**MEMORANDUM**

**SUBJECT:** Trail View Homes: Preliminary & Final Plat

The Development Review Committee recommends approval of the preliminary and final plat applications, subject to the following conditions:

DRAWN BY: <i>SEG</i>	CHECKED BY: <i>--</i>
SCALE: <i>(11" x 17')</i>	
JOB NUMBER: <i>G006.004</i>	
DATE: <i>3/19/19</i>	SHEET: <i>C.01</i>

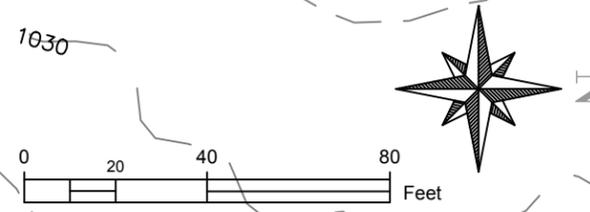
7. Sanitary and water laterals go directly under several suggested stormwater attenuation areas. If the homeowner decides to excavate this will result in less than 5' of cover over the pipe. The laterals shall be offset from the suggested stormwater attenuation areas.

12. Stormwater attenuation note on Sheet C.01 should be revised to "Stormwater Attenuation Areas. See Stormwater Management Plan. Minimum Retained Volume Shall be 2,000 Cubic Feet, as Measured Below The Lowest Outlet. Exact Shape and Location to be Determined by Homeowner Preference. Turf Grass Shall Not Be Planted Within Stormwater Attenuation Area."

1. Stormwater attenuation areas cannot be located on top of the proposed sanitary sewer and water main. The Applicant's plans shall be revised accordingly.

2. Stormwater attenuation note on Sheet C.01 should be revised to "Stormwater Attenuation Areas. See Stormwater Management Plan. Minimum Retained Volume Shall be 2,000 Cubic Feet, as Measured Below The Lowest Outlet. Exact Shape and Location to be Determined by Homeowner Preference. Turf Grass Shall Not Be Planted Within Stormwater Attenuation Area."

DRAWN BY: <i>SEG</i>	CHECKED BY: <i>--</i>
SCALE: <i>(11" x 17')</i>	
JOB NUMBER: <i>G006.004</i>	
DATE: <i>3/19/19</i>	SHEET: <i>C.02</i>

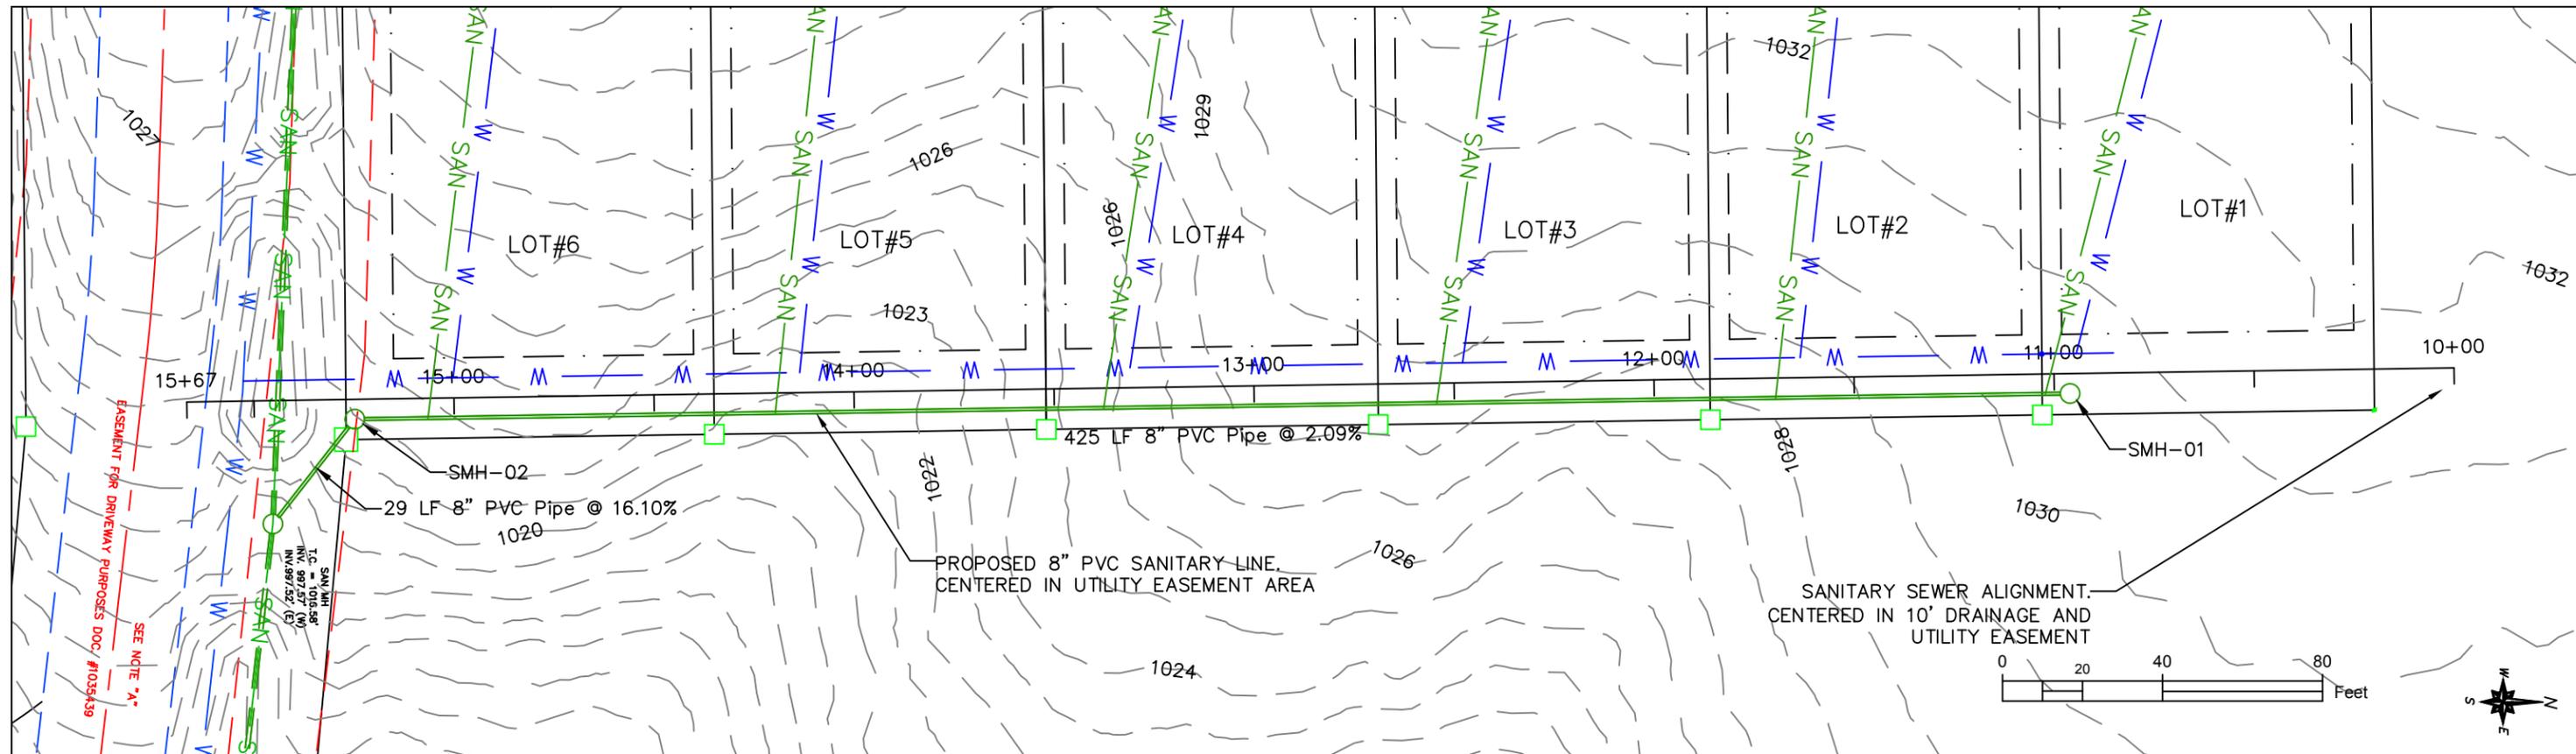
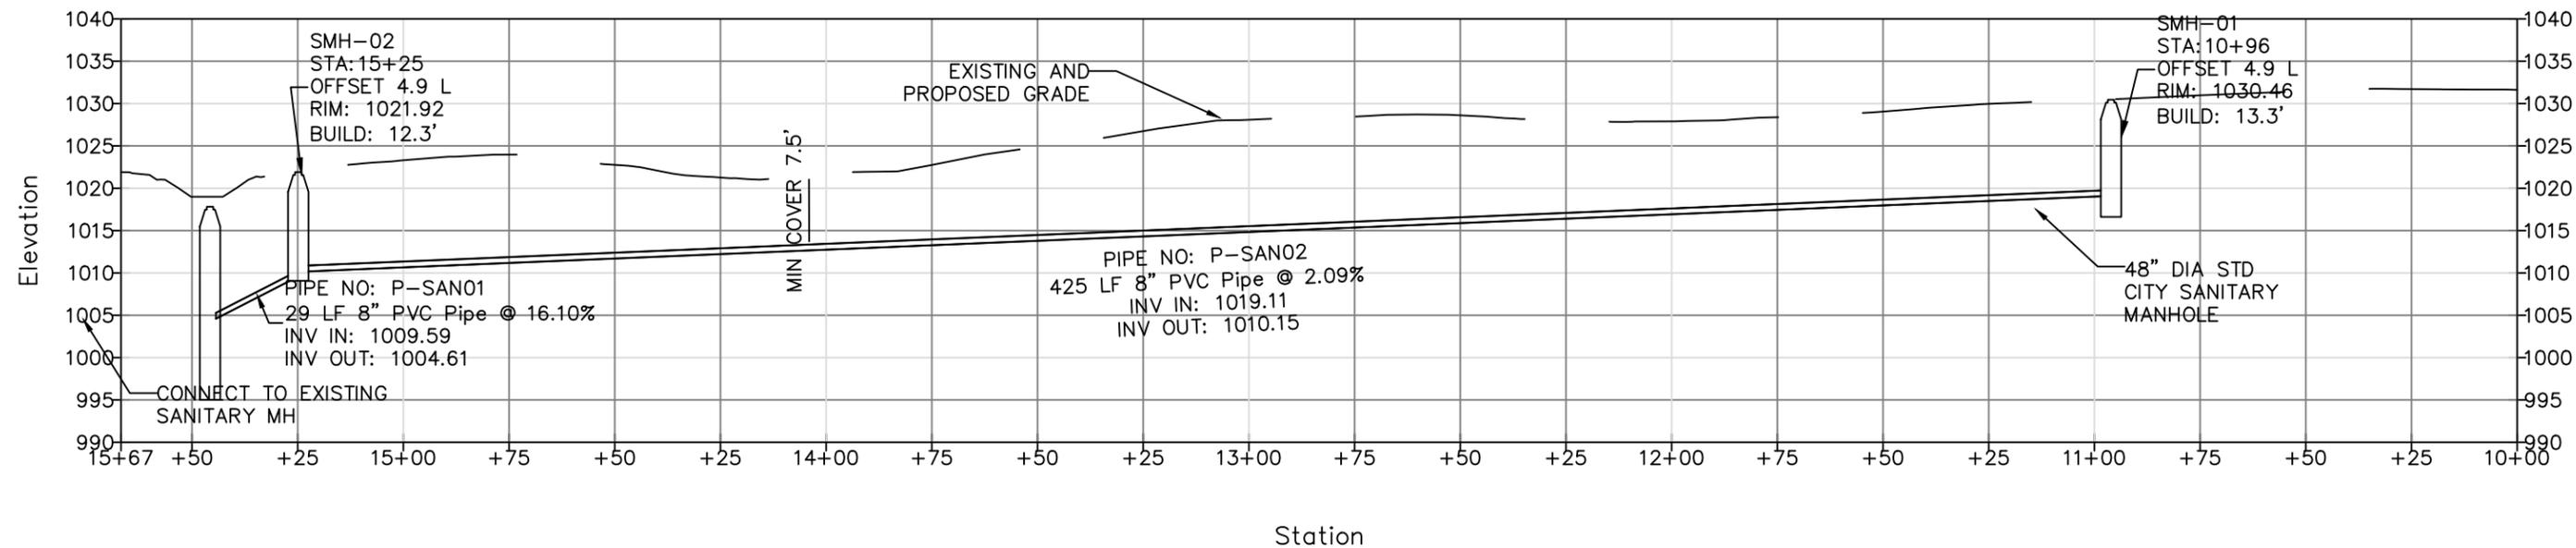
1. The proposed connection to the existing sanitary manhole will require a core drill, use rubber boot, inside drop, and re-pour the invert to create the new flow line.

2. The proposed sanitary sewer from MH 1 to MH 2 is 425 feet. 400 feet is considered the maximum length. A manhole shall be required in the middle.
3. The City sanitary manhole shall consist of Neenah casting (R-1642 or equal).

DATE: *3/19/19* SHEET: *C.03*

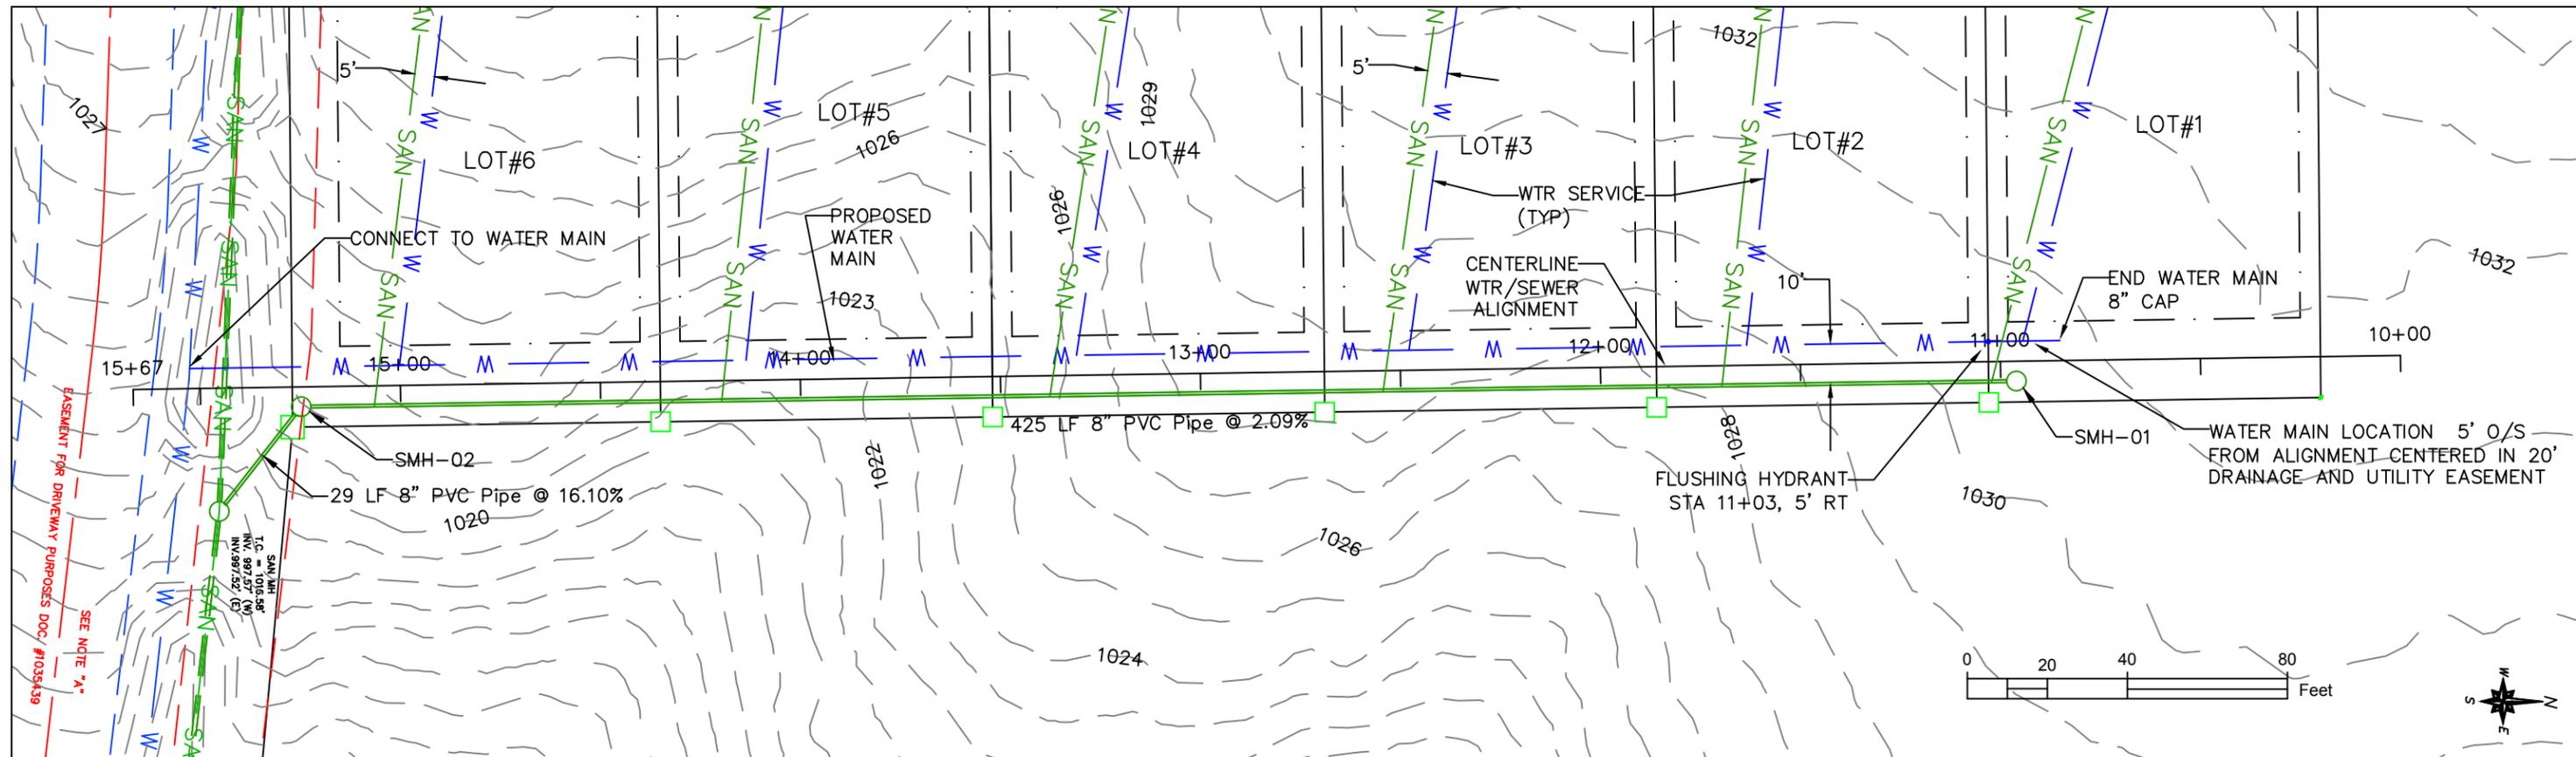
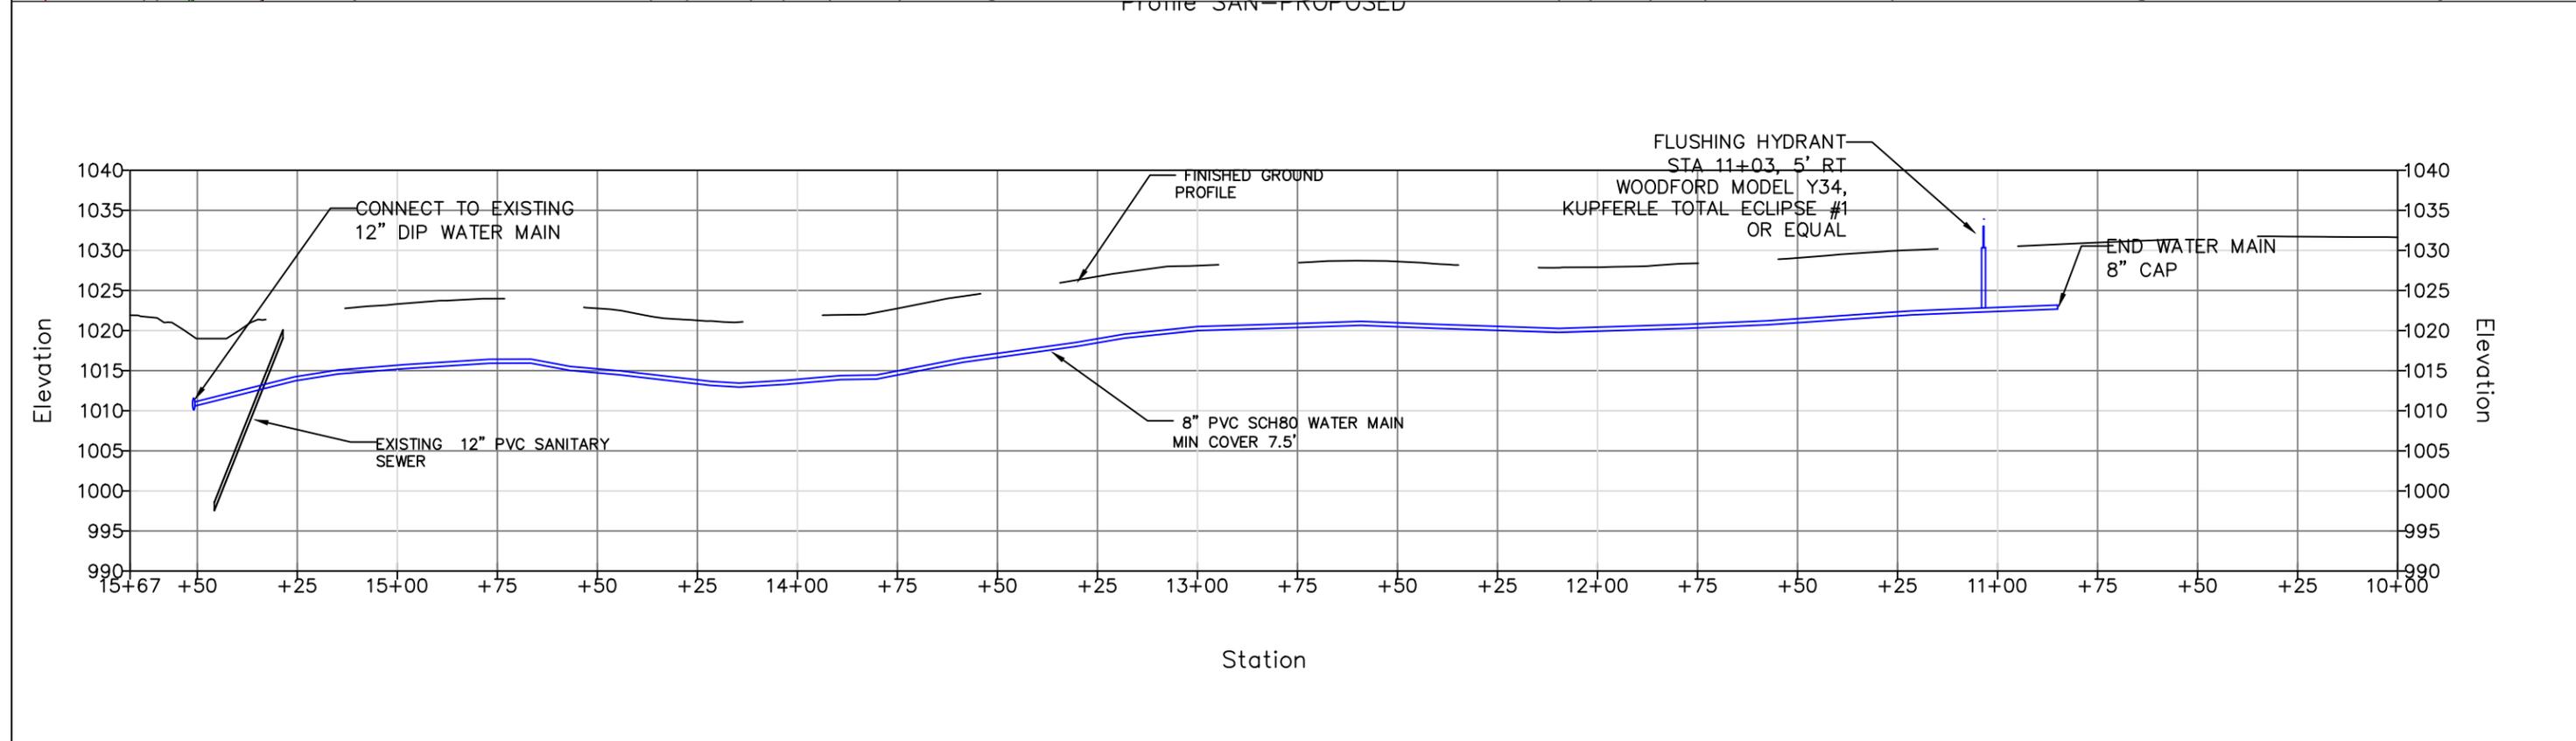
4. The proposed water main should have a gate valve at the connection point. A wet tap shall be required to eliminate a water service outage. All joints and mechanical joints shall be strapped.

5. The proposed water main is Schedule 80 PVC. Ductile Iron (Class 52) shall be required.
6. The proposed water main does not terminate at an approved flushing device. The proposed flushing devices, which are intended for non-potable uses, will not provide sufficient flushing velocity and, in any event, are not located at the end of the water main. A Waterous Pacer WB67 Hydrant shall be required at the end of the water main with a gate valve. Field locking gaskets are required on the last three joints.
